SUPPLEMENT NO. 1

SAFETY EVALUATION

PRAIRIE ISLAND UNITS 1 & 2

DOCKET NOS. 50-282 & 50-306

FIGURE 6.5-1
MAIN STEAM PIPING
NSP-PRAIRIE ISLAND UNIT 1

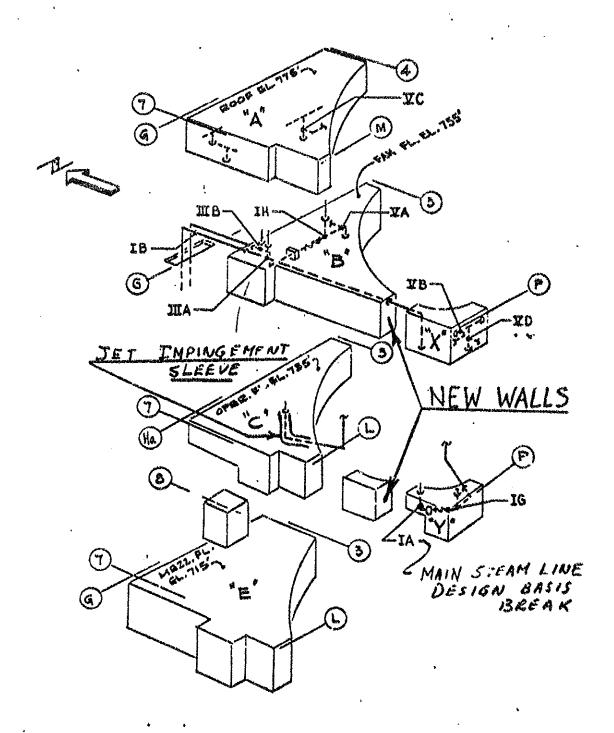
The portion of the Unit 1 main steam piping system which attained the calculated stress levels designated for design basis breaks is located in compartment "Y" of the auxiliary

building (see Figure 6.5-1 of this supplement). New walls will be built within existing auxiliary building compartments (north walls of compartments "Y" and "X" in Figure 6.5-1) to seasure isolation of the postulated breaks in the auxiliary building. Existing openings in the exterior walls (south walls of compartments "Y" and "X") of the isolated compartments or blowout panels (if required to obtain adequate vent area) will be used to provide pressure venting. An encapsulation sleeve will be provided to limit the steam blowdown rate into compartment "Y." The steam is vented to compartment "X" through a floor grating. There is no equipment in compartments "X" or "Y" that would be required to bring the plant to safe cold shutdown as a result of the steam line rupture in compartment "Y."

Design basis break locations of the steam branch pipe runs are also shown in Figure 6.5-1 of this supplement. Encapsulation sleeves will be installed over the branch pipe at the locations of the design basis breaks and the pipe will be designed to prevent separation of the ruptured pipe from the sleeves. The sleeves will be designed to restrict the flow from a ruptured pipe so that overpressurization of the compartments will not occur.

The temperature and force of jets from design basis cracks in the high-energy fluid pipes have been calculated by the applicant as a function of distance from the pipe. Cable trays and structures, such as closed doors, that are required for safe shutdown will be protected by jet impingement barriers if they are close enough to be damaged by the jet temperature or force. The locations of impingement barriers for the high-energy lines are shown on FSAR Figures I.3-1, I.4-1, IA-1, IA-2, and IA-3. In compartment "C," a jet impingement sleeve will be put around the main steam pipe to protect nearby cables and cable trays (see Figure 6.5-1 of this supplement).
